RE: Swim Labs
8110 Holly Ave NE
Grading Plan Stamp Date: 7/19/19 & 7/24/19
Drainage Report Stamp Date: 7/25/19
Hydrology File: C20D082

Based on the submittal received on 7/25/19, the grading plan and drainage report cannot be approved until the following are corrected:

**RE: Swim Labs
Grading and Drainage Plan
Hydrology File: C20D082**

SWIM LABS GRADING & DRAINAGE PLAN

Designed: <i>CP/DMG</i>	Drawn: <i>CP</i>	Checked: <i>DMG</i>	Sheet <i>C1</i>
Scale: <i>1" = 20'</i>	Date: <i>7/24/2019</i>	Job: <i>A19003</i>

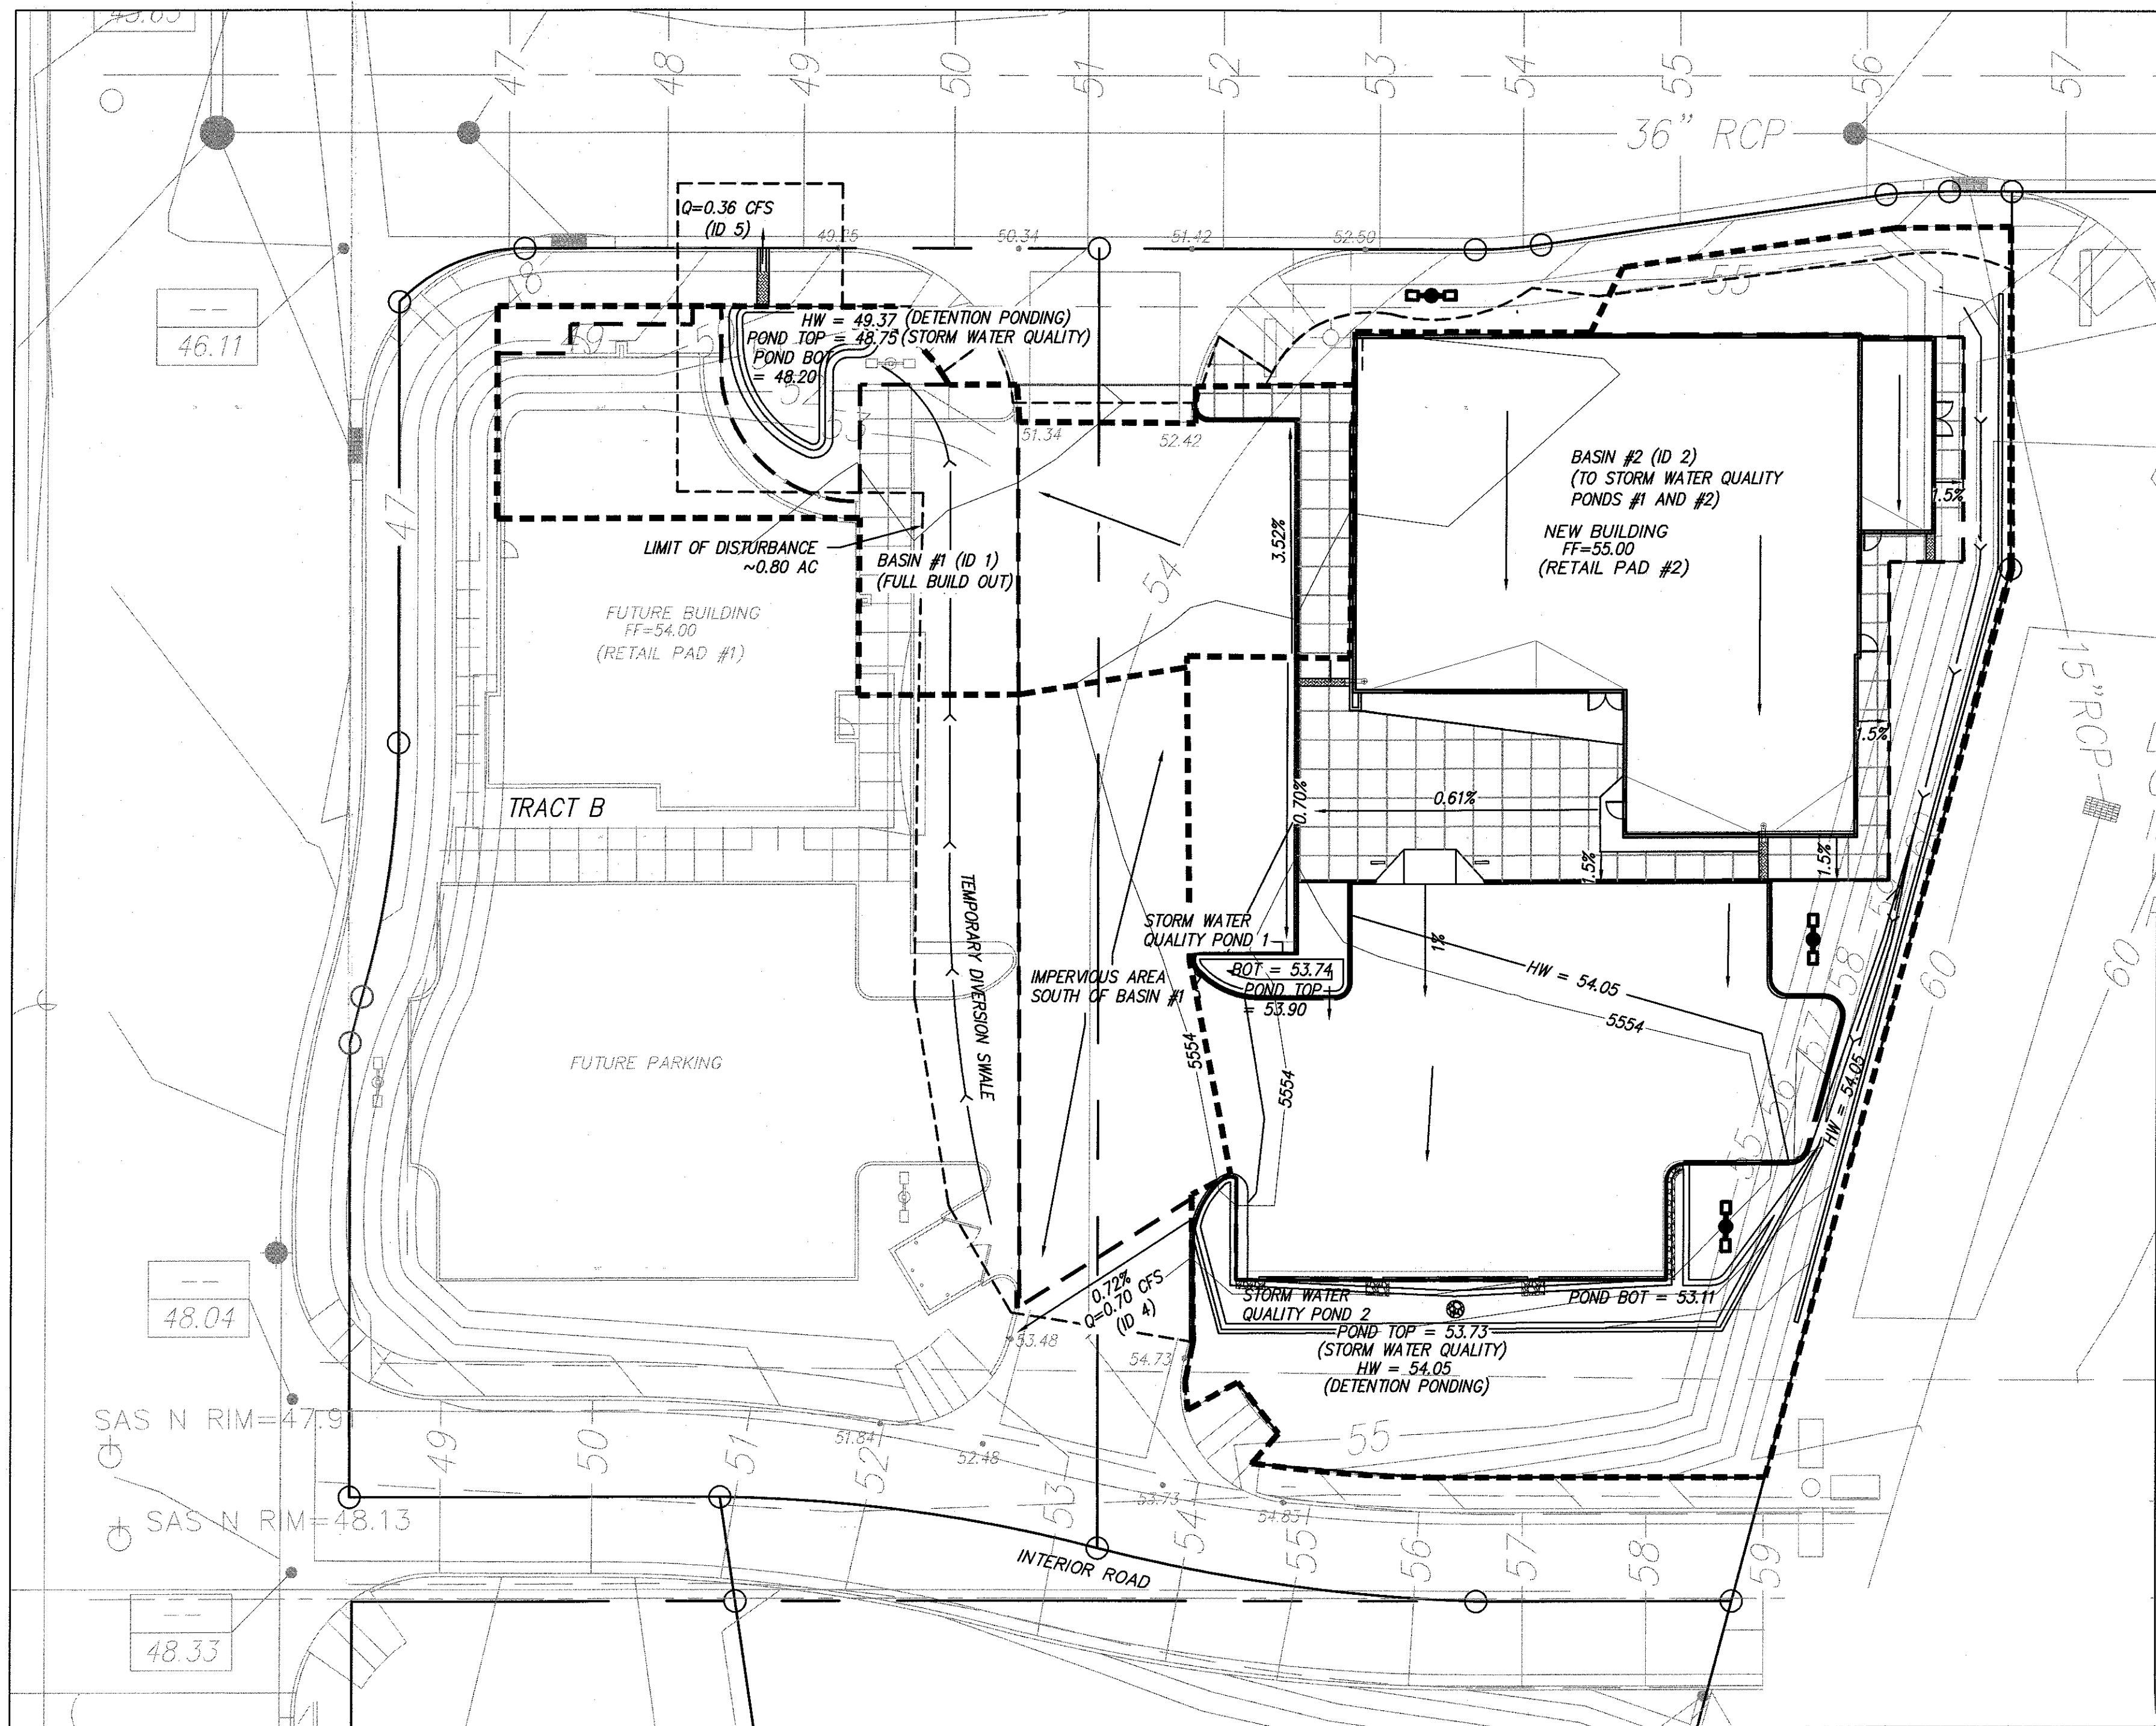
1. Provide sections through the east boundary showing the proposed retaining wall, property lines, existing and proposed grades. In accordance with DPM Ch.22, section 5 part B, grading and wall construction near the property line may not endanger adjacent property or constrain its use.

2. Any private encroachment into neighboring private property will require written and signed permission from both property owners.
3. Include a detail where the retaining wall crosses over the private storm drain; ensure adequate clearance.

5. Provide project datum. This needs to be on the plan where the benchmark is cited. The benchmark, existing survey, and proposed work all need to be converted to NAVD88 and NAD 83.

6. The proposed contours need to be cleaned up. For instance, the 54' contour cuts through the building (FF=55'), the 53' contour seems to be missing, and there appear to be different contours used for the ponds that don't tie-in to anything.

7. Hydrology recommends against using the parking lot as dead storage for ponding water (Pond 2).
8. An SO-19 Permit will be required for the sidewalk culvert and should be included on the request. Please include the [standard SO-19](#) notes on the grading plan.

9. Discharge from this site needs to be limited to 0.93cfs per the approved master plan; do not rob capacity from the adjoiner (Pad 1).
10. Remove the open channel and extend the plate to the curb and 1' beyond back of sidewalk; also remove the non-standard plate detail and build per Std Dwg 2236.
